**BEFORE THE SOUTH DAKOTA PUBLIC UTILITIES COMMISSION**

**DOCKET EL18-003**

**IN THE MATTER OF THE APPLICATION BY DAKOTA RANGE I, LLC AND  
DAKOTA RANGE II, LLC FOR A PERMIT OF A WIND ENERGY FACILITY IN  
GRANT COUNTY AND CODINGTON COUNTY, SOUTH DAKOTA, FOR THE  
DAKOTA RANGE WIND PROJECT**

**DIRECT TESTIMONY OF JON THURBER  
ON BEHALF OF THE COMMISSION STAFF  
MAY 4, 2018**

**Figure 12**  
**Land Use and Project Layout**  
 Dakota Range  
 Wind Energy Facility  
 SDPUC Application  
 003077

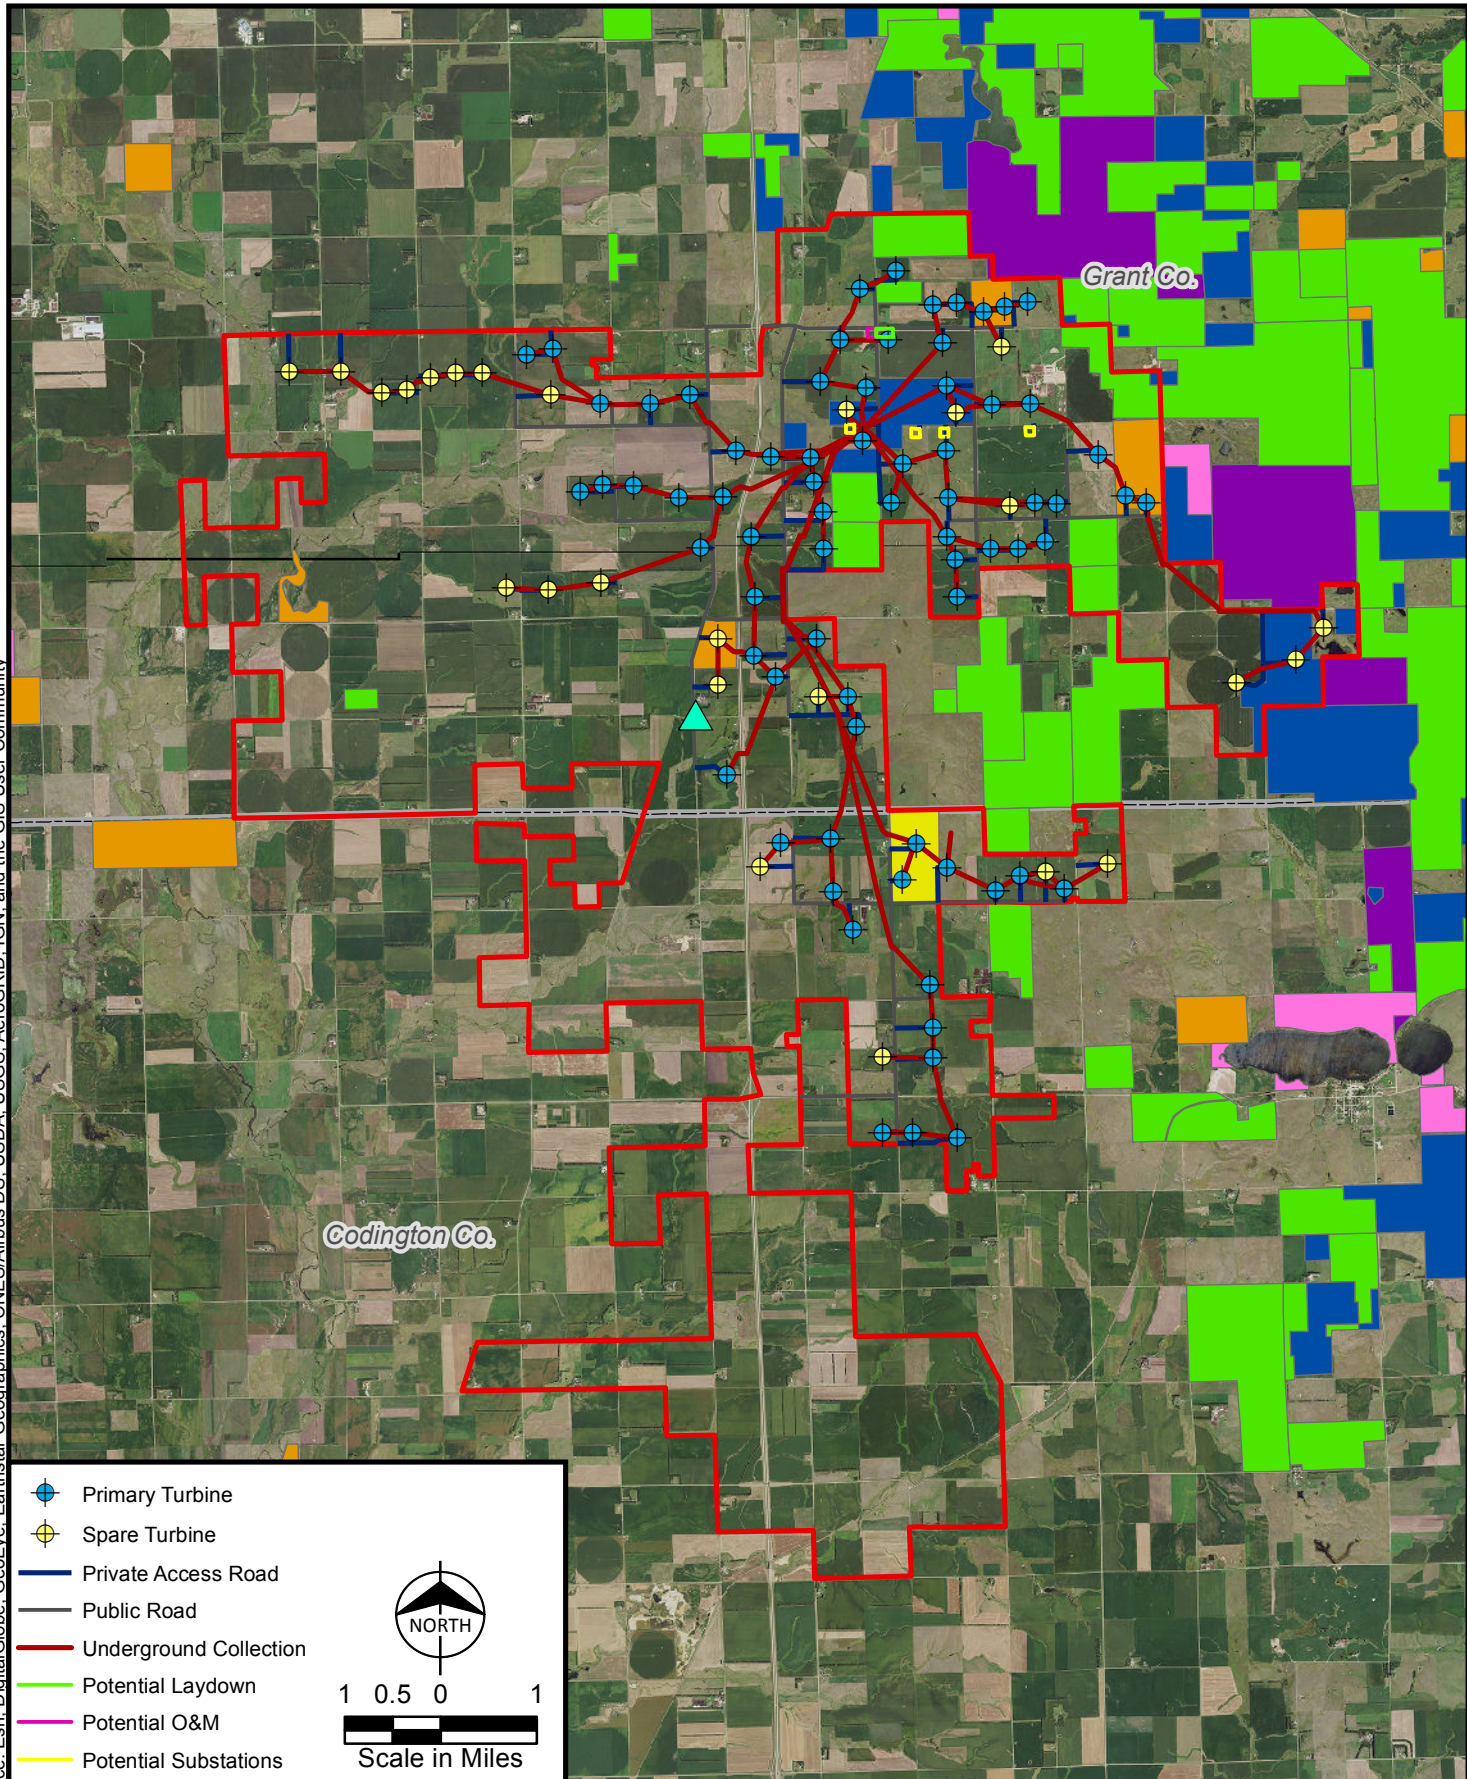
- 2-3) Referring to section 9.0, it is identified that “Figure 12 shows the locations of cemeteries, places of historical significance, and other community facilities (i.e. schools, religious facilities) within or near the project area.” Please identify how these locations are displayed on Figure 12.

- 2-4) Please provide Figures 12 and 13 with the proposed turbine layout included.

Jennifer Bell: One church and an associated cemetery are located within the Project Area. This church and associated cemetery is displayed on Figure 12 as a “Public, commercial, and institutional use” indicated by a purple hexagon. Note that the church and cemetery is the easternmost purple hexagon shown on Figure 12. The church and associated cemetery is also displayed on Figure 13 as a “Church and Cemetery” indicated by a turquoise triangle.

### Dakota Range Buildable Within 500ft From Turbine

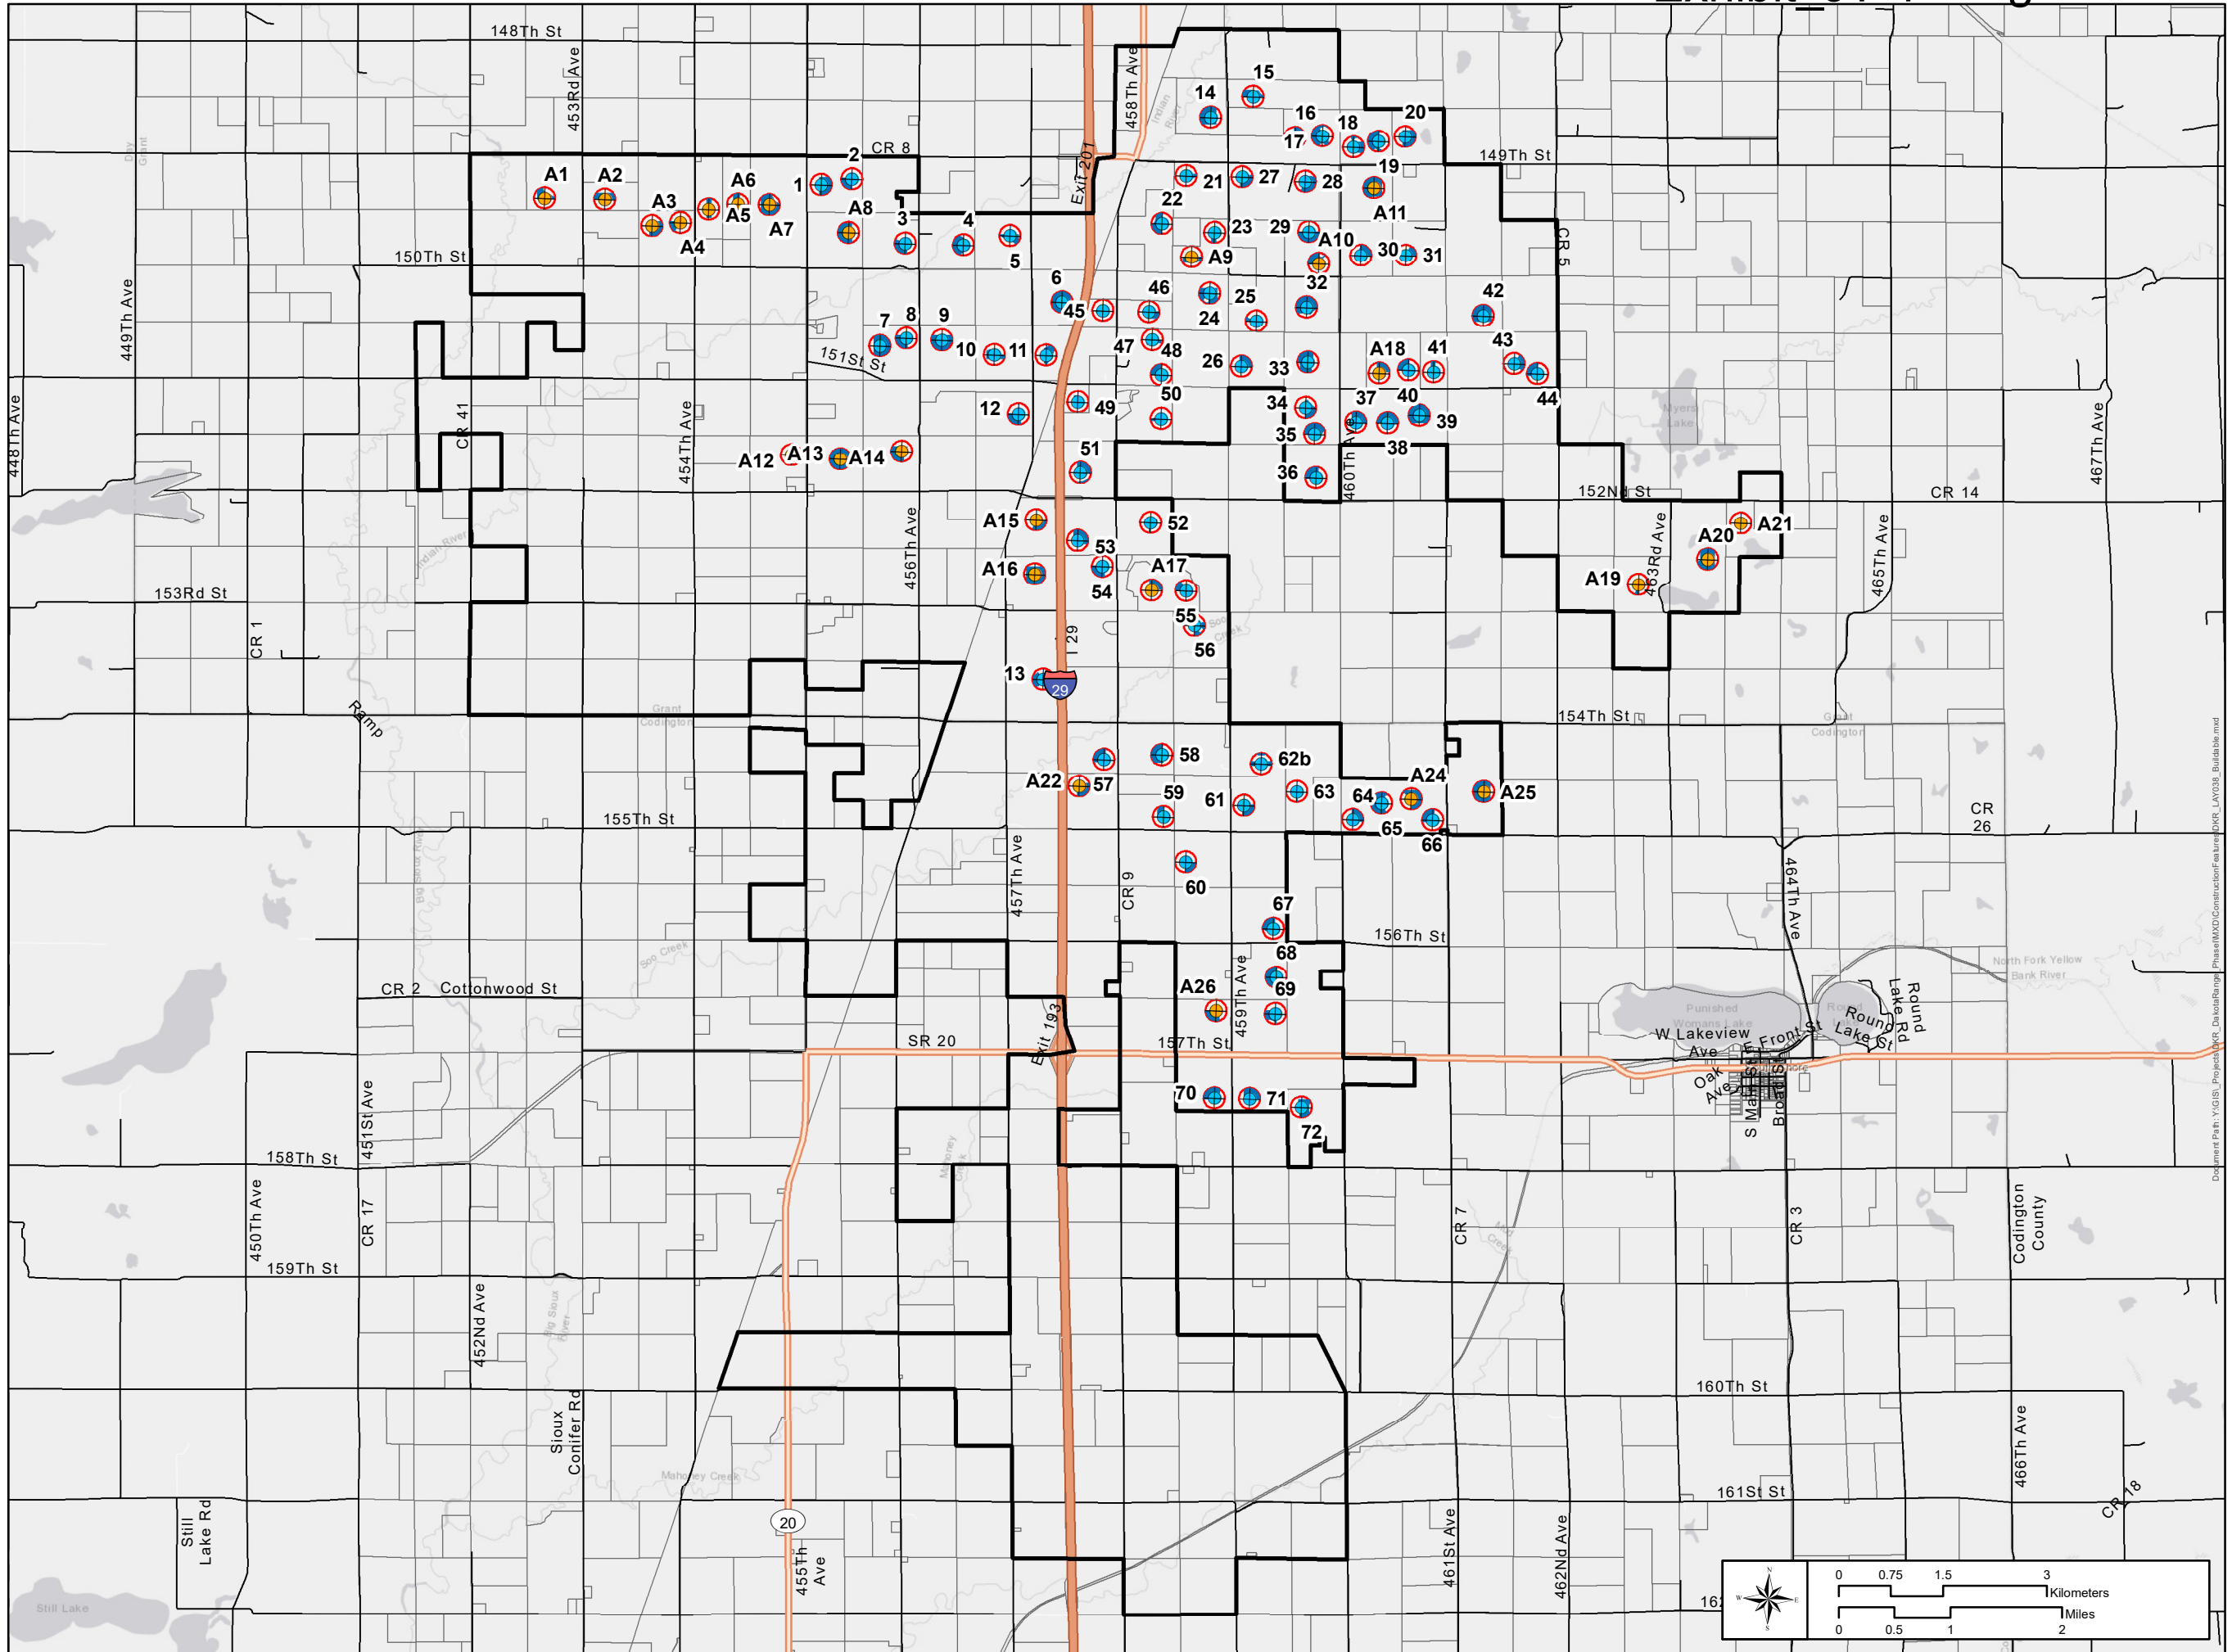
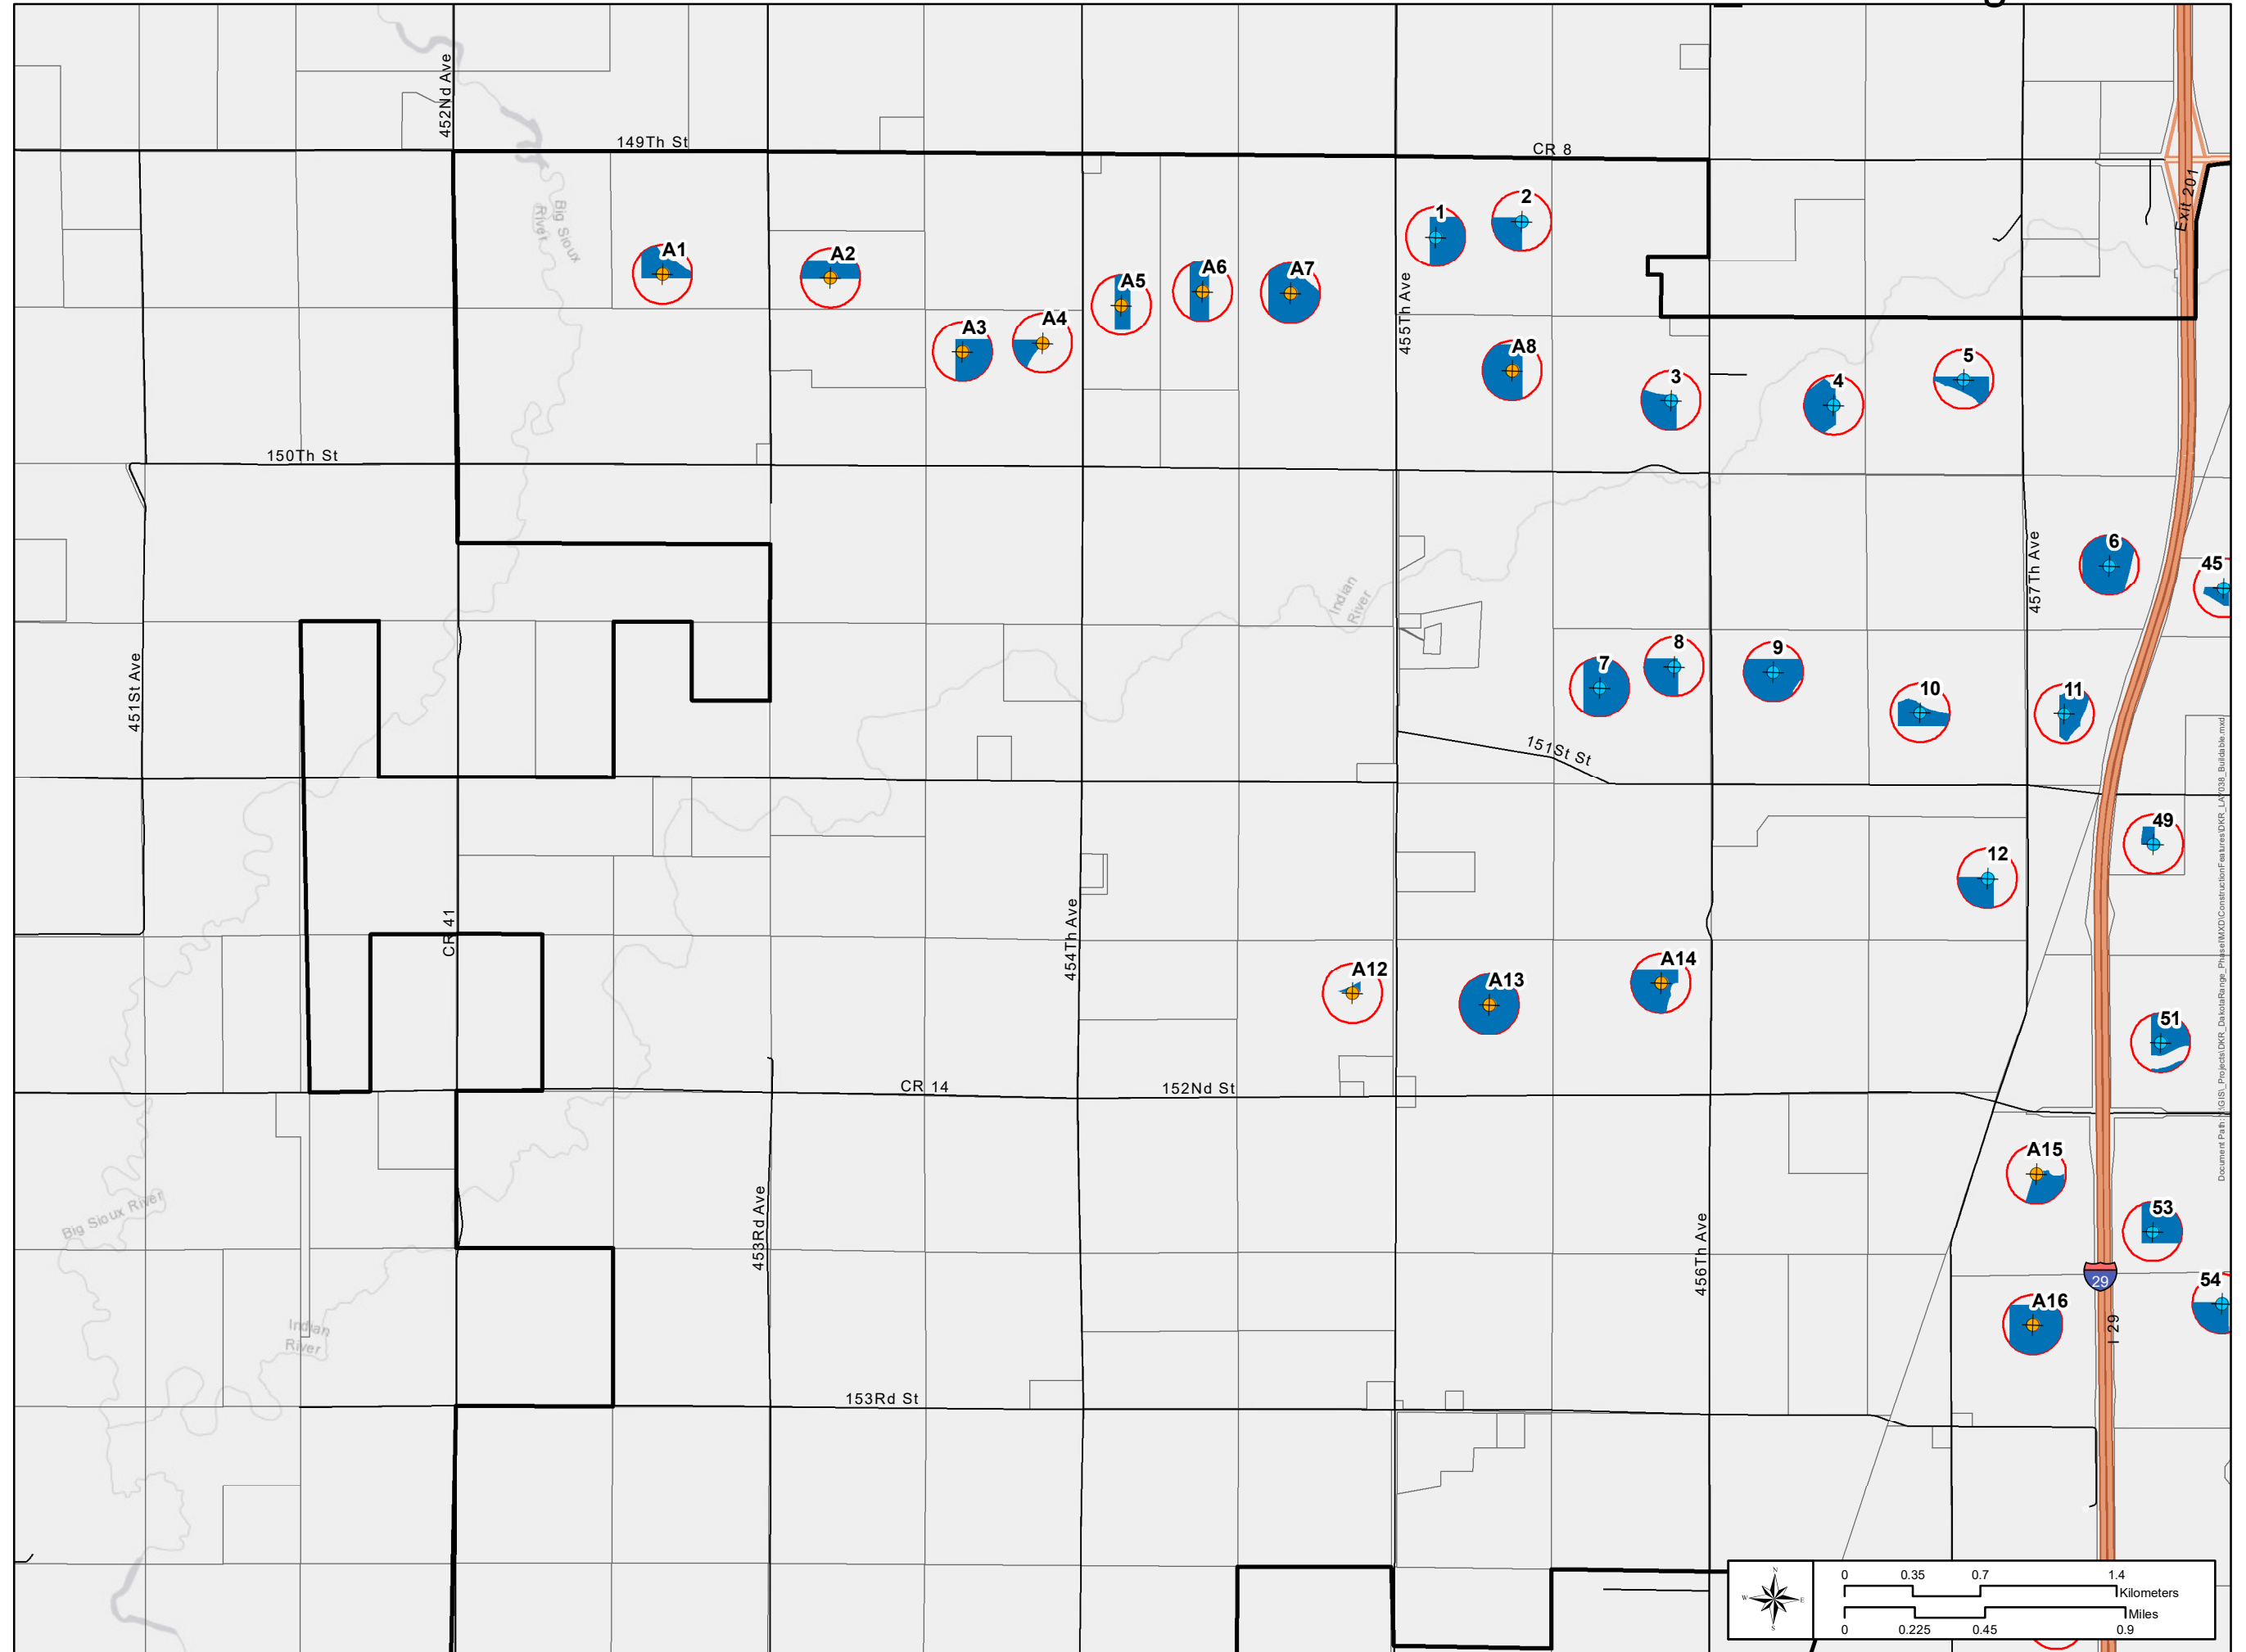
- 7-3) Please refer to the Constraints Map depicted on Figure 5:**

- c) **Please resubmit Figure 5 to also show the turbine flexibility requested, and submit Figure 5 with more detail (ie – broken out into 4 or 6 sub-regions of the project).**

Brenna Gunderson: For the purposes of Figure 5, the "buildable area" was developed by incorporating setback requirements and other factors related to the siting of wind turbines.

Brenna Gunderson: Turbines 16, 18, 19, and 20 are shown in a non-Buildable Area as a result of an error in creating Figure 5 in which an outdated version of the Buildable Area was inadvertently used.

Brenna Gunderson: See the attached revised Figure 5 maps.
